## NINE MILE POINT NUCLEAR STATION

**SUBJECT:** Nine Mile Point Nuclear Station  
Unit No. 2; Docket No. 50-410

Response to Request for Additional Information Regarding Nine Mile Point Nuclear Station, Unit No. 2 – Re: The License Amendment Request for Extended Power Uprate Operation (TAC No. ME1476) – Anticipated Transient Without Scram Simulator Tests and Net Positive Suction Head for Emergency Core Cooling Systems

**RESPONSE TO REQUEST FOR ADDITIONAL INFORMATION  
REGARDING LICENSE AMENDMENT REQUEST FOR EXTENDED  
POWER UPRATE OPERATION**

Figure 28  
Transient Test EPU Turbine Trip ATWS MELLLA  
RPV Dome Pressure (rrpdome)

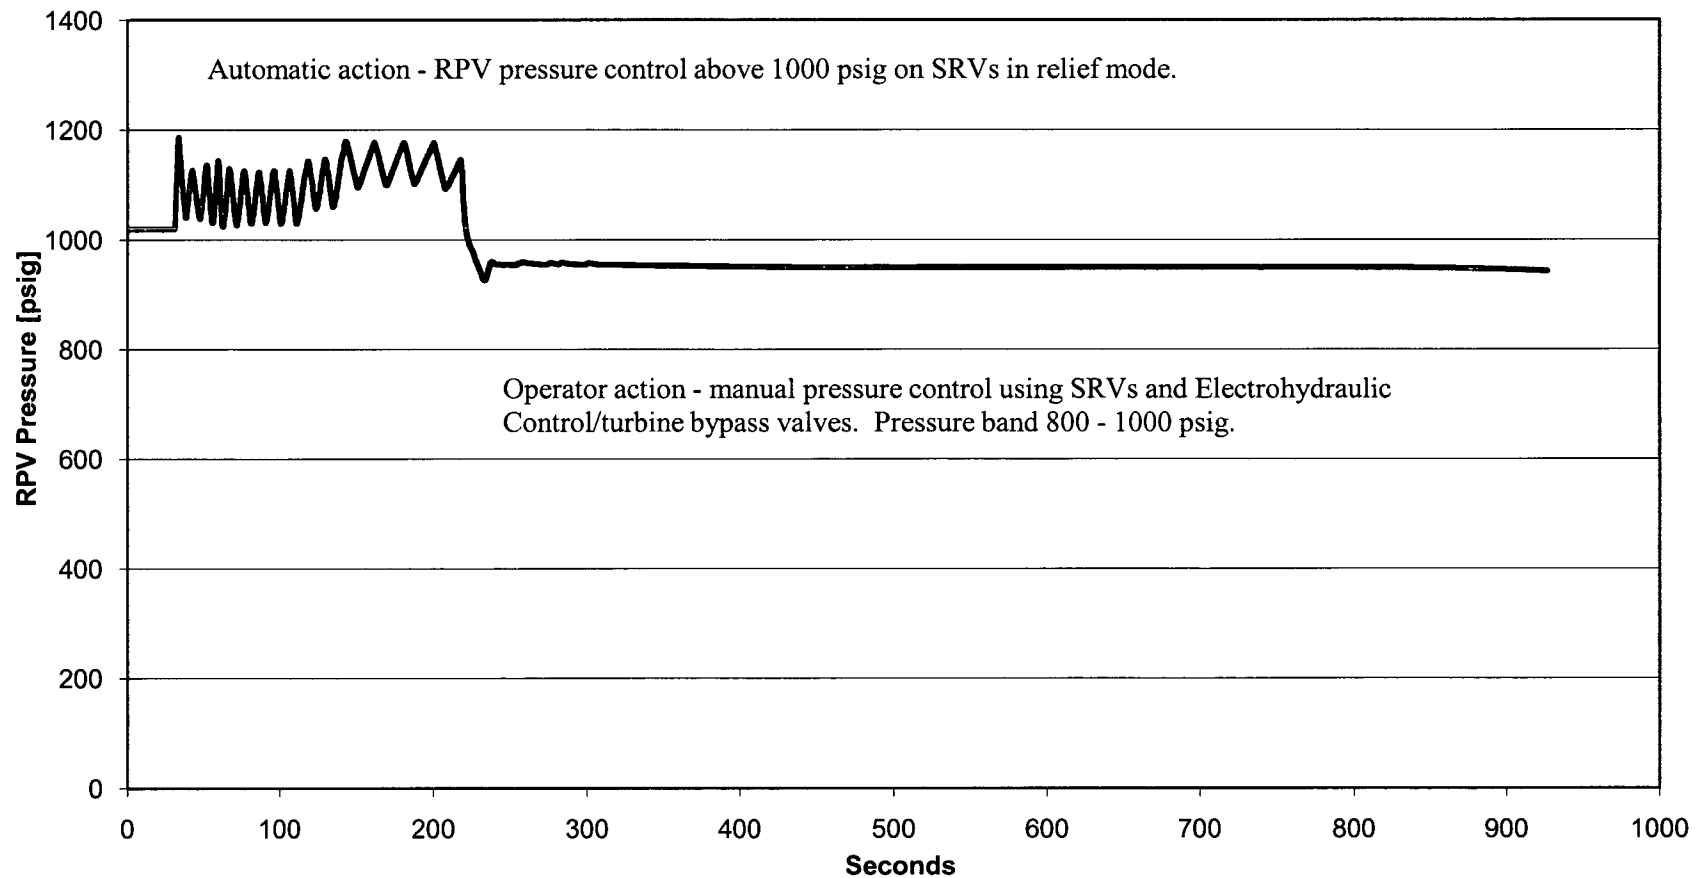
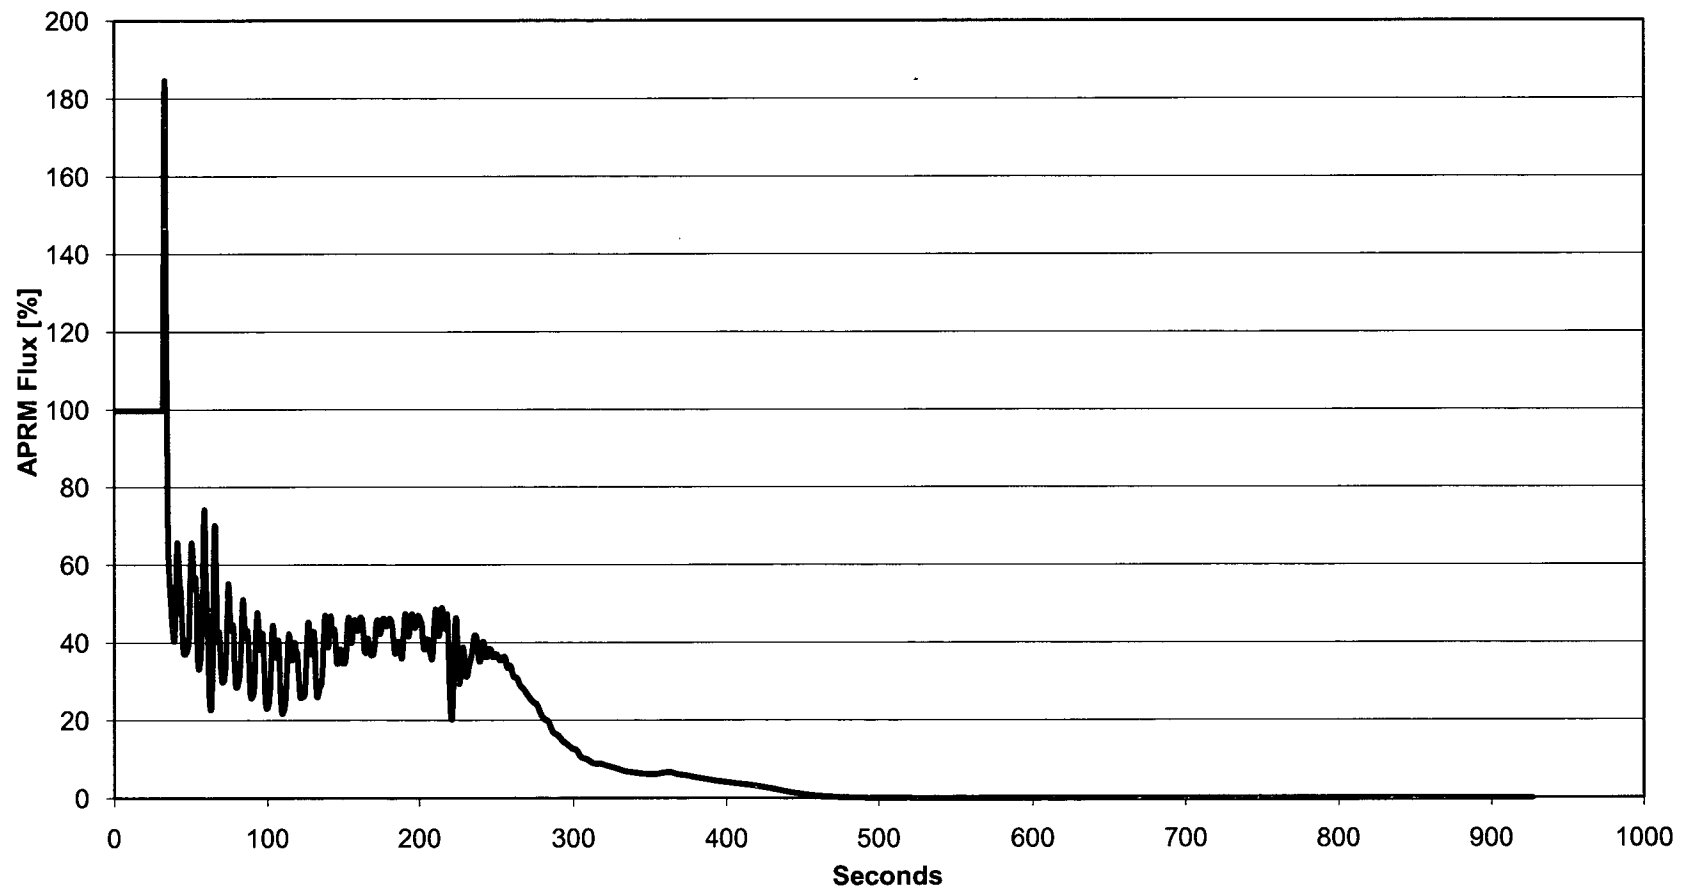
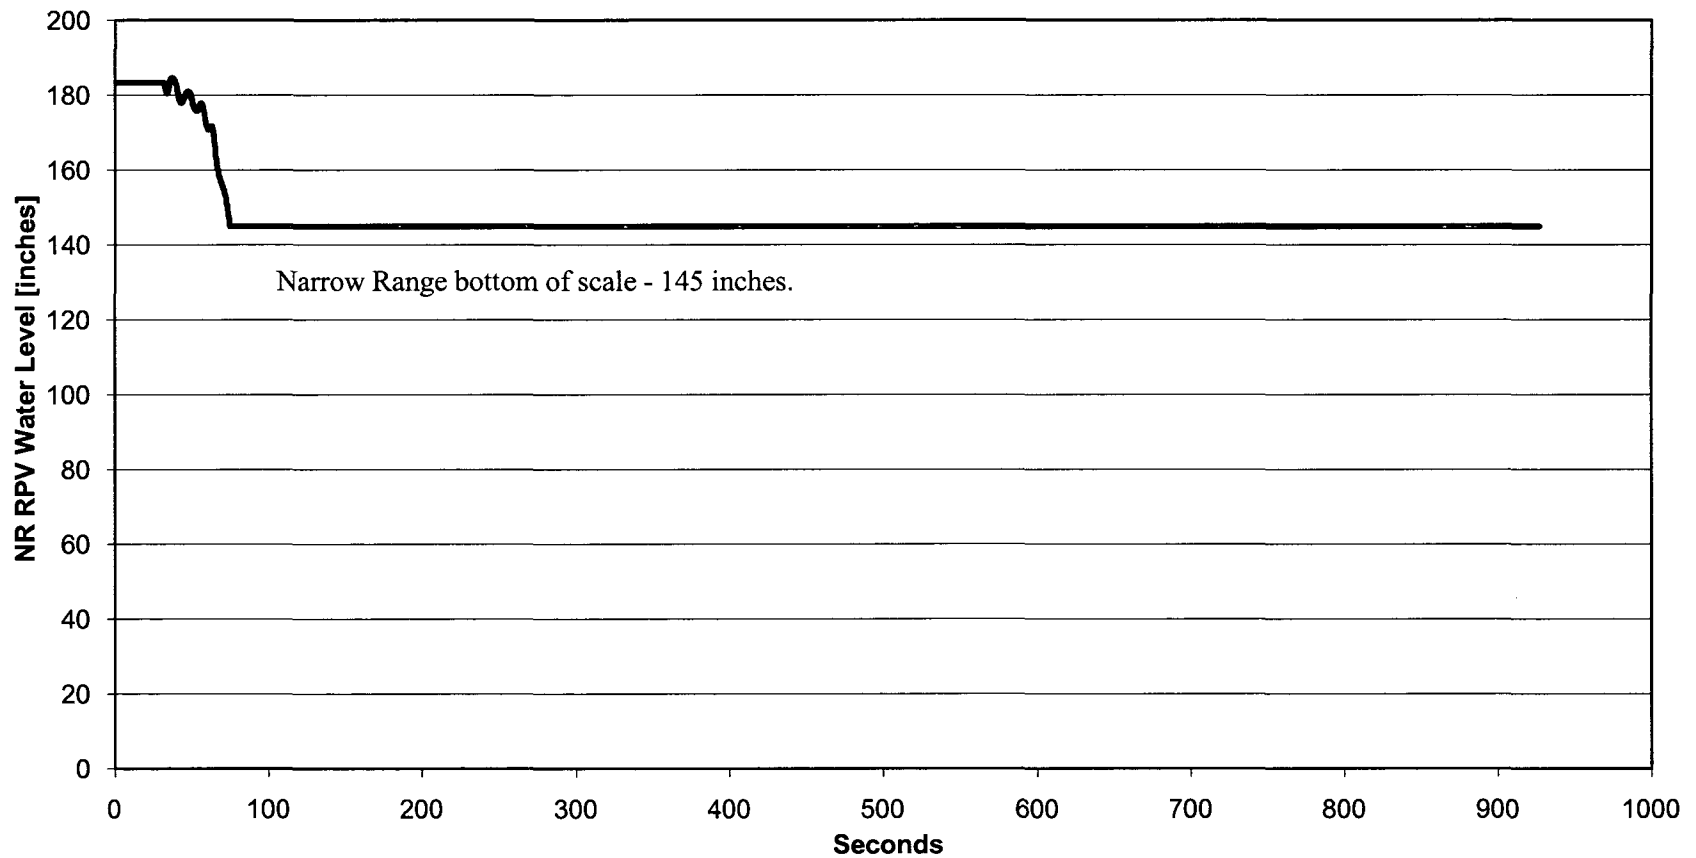
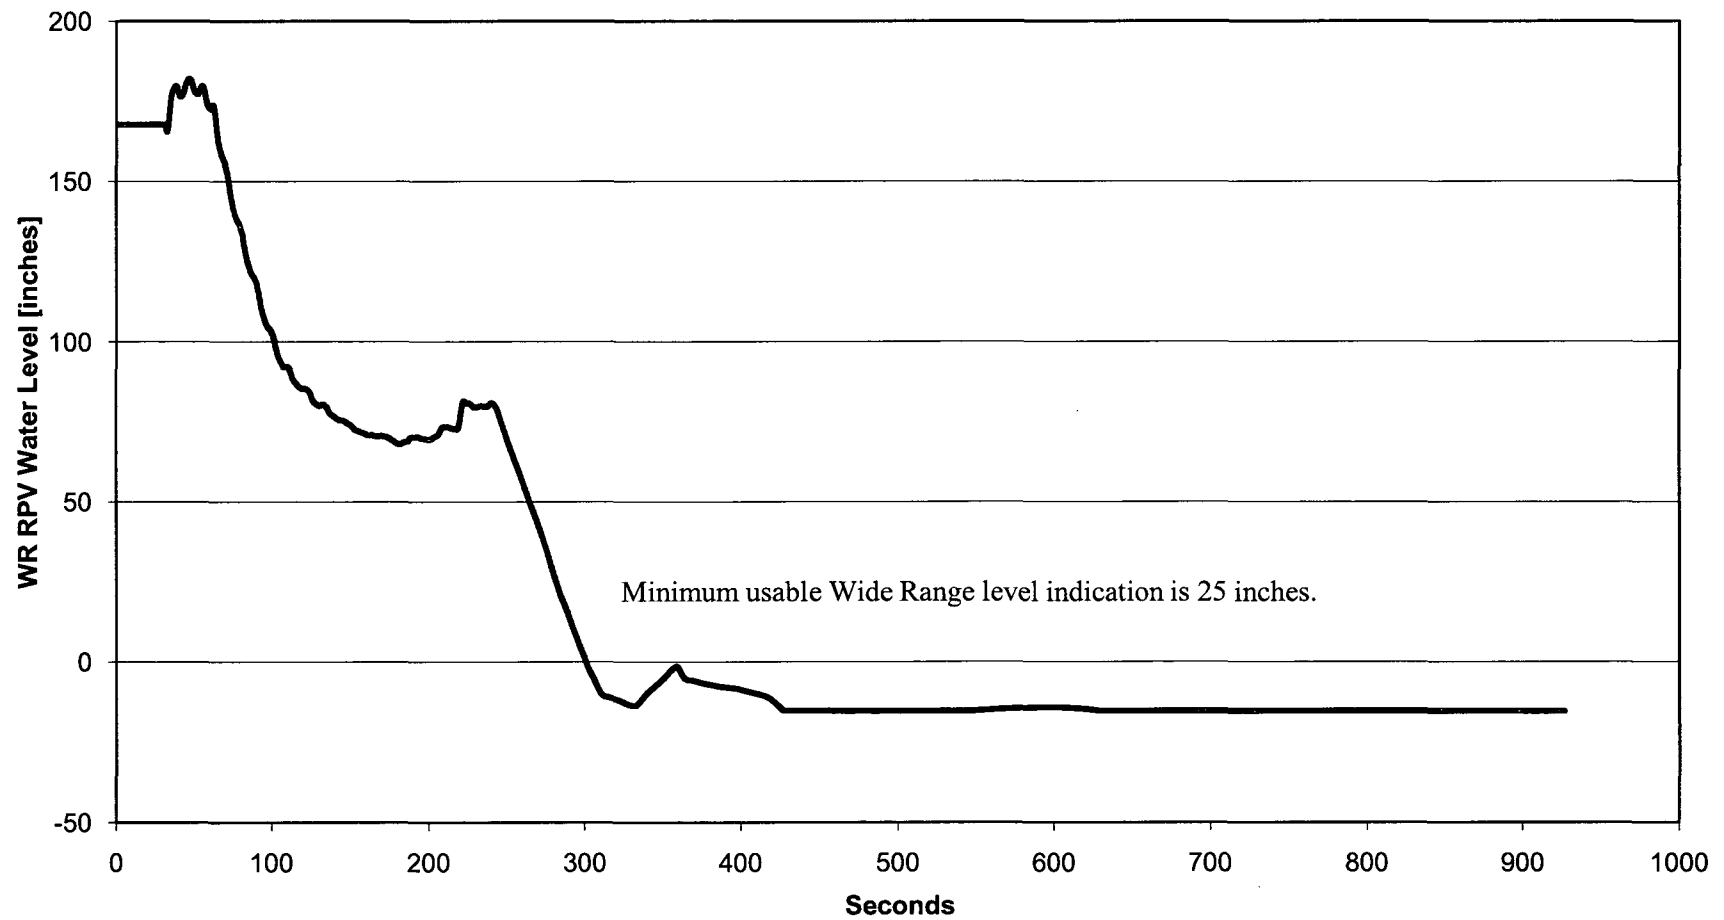
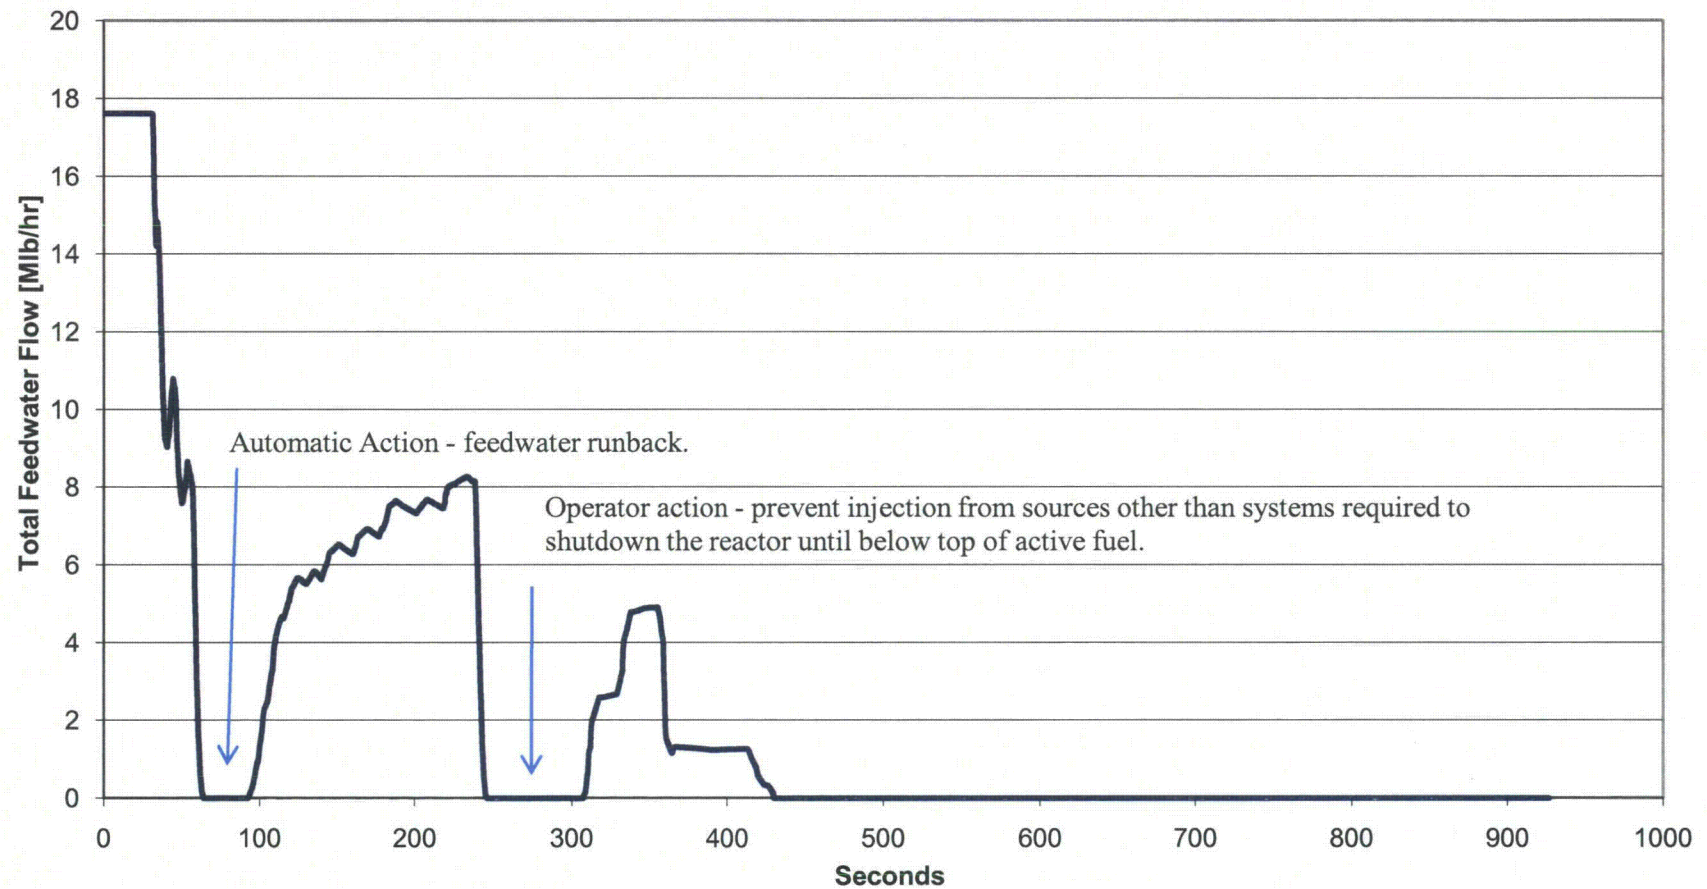
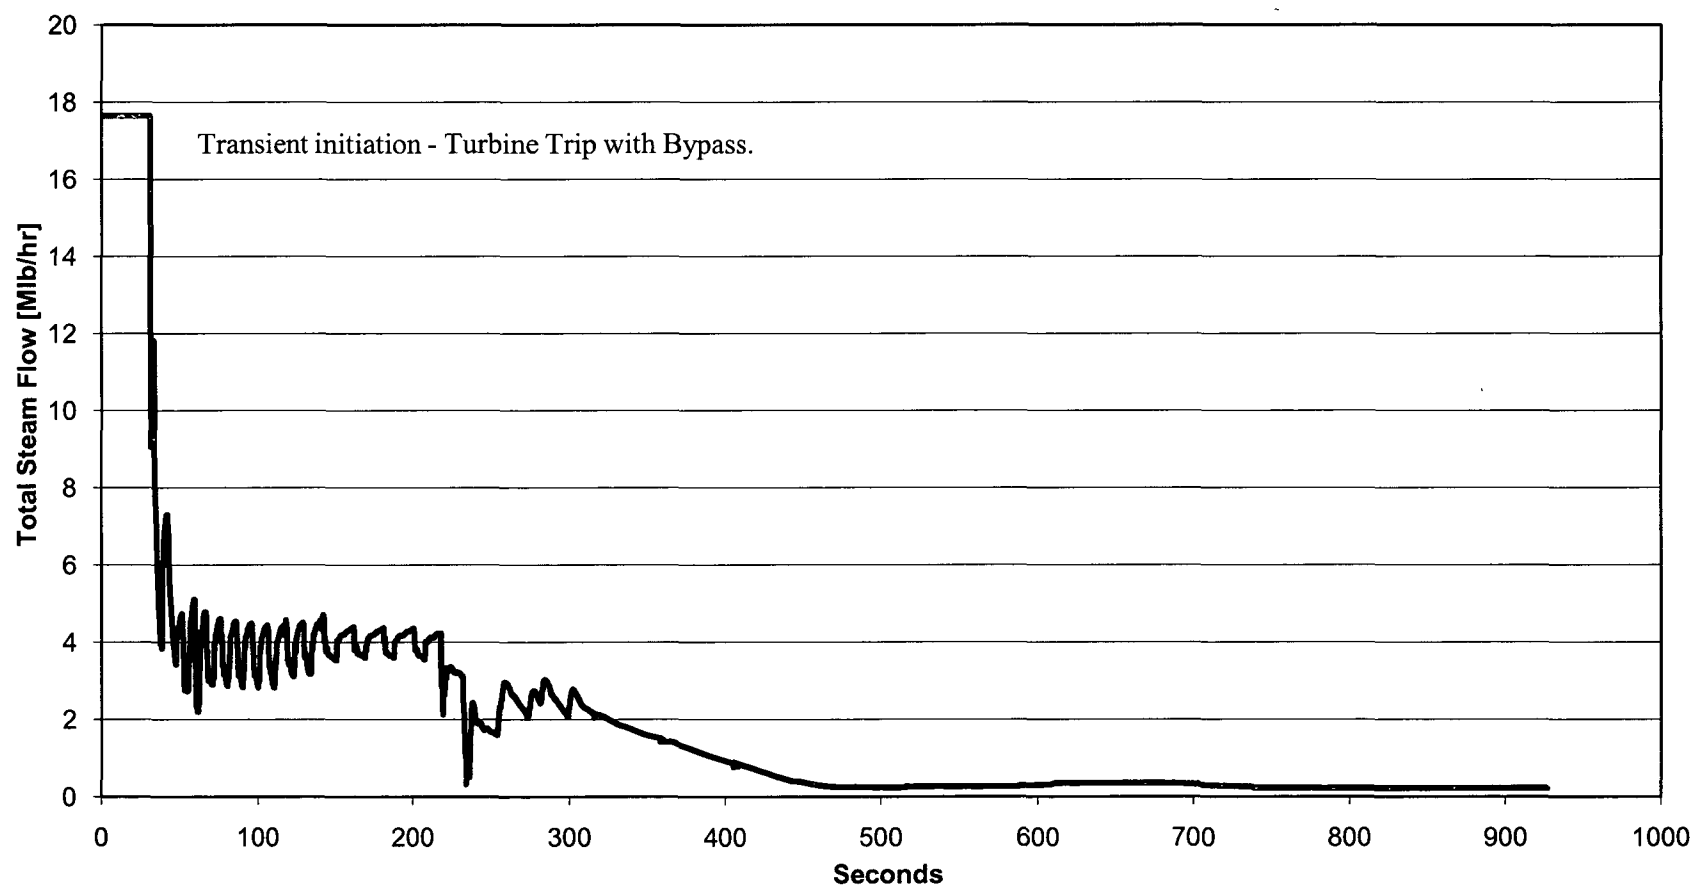
- 1) Provide the sequence of both events with the transient response(s) corresponding to ATWS emergency operating procedure actions (e.g., turbine trips, recirculation pump trips, turbine bypass valves open, power increases, water level reduction, standby liquid control system injection, to steady state/oscillation under control, etc.)*
- 2) For clarity of the data tables for both the MSIV closure and turbine trip ATWS EPU events, provide the full name/nomenclature with description or definition of each column field (e.g., rrp dome, nmapmfx\_z, fws1a101, etc.).*
- 3) In addition to the [Reactor Pressure Vessel] RPV Pressure vs. Time plots in both events, please include an overlay plot of Power versus Time (i.e., show power oscillations/response corresponding to the RPV pressure response).*

T = 0	Main turbine trips.
T = 0.5	All five turbine bypass valves are full open
T = 1	High reactor pressure initiates RRCS. Reactor Recirculation pumps transfer to slow speed
T = 2	Peak neutron flux of 185%
T = 2.8	Peak Reactor Pressure Vessel (RPV) pressure of 1187 psig
T = 26	Automatic action – Reactor Recirculation pumps trip to OFF, feedwater runback terminates feedwater injection
T = 104	Operator action – RPV water level stabilized following feedwater runback in a band of 50 to 80 inches on wide range level indication.
T = 110.6	Automatic action – Boron injection initiated
T = 153.6	Suppression Pool temperature reaches Boron Injection Initiation Temperature (BIIT) of 110°F
T = 191	Operator action – pressure band of 800 – 1000 psig established using Safety Relief Valves (SRVs)
T = 216	Operator action – injection sources other than Reactor Core Isolation Cooling (RCIC), Control Rod Drive (CRD) and boron are terminated and prevented

T = 269      Suppression Pool temperature reaches maximum value of 120.7°F  
T = 338      Operator action – First loop of Residual Heat Removal (RHR) is in Suppression Pool cooling at rated flow of 7450 gpm  
T = 373      Average Power Range Monitor (APRM) neutron flux is downscale, less than 4%  
T = 425      Operator action – second loop of RHR is in Suppression Pool cooling at rated flow of 7450 gpm  
T = 465      Reactor is in hot shutdown as indicated by neutron flux <0.1% on APRMs

Figures 28 through 54 depict the plant response for a number of parameters.
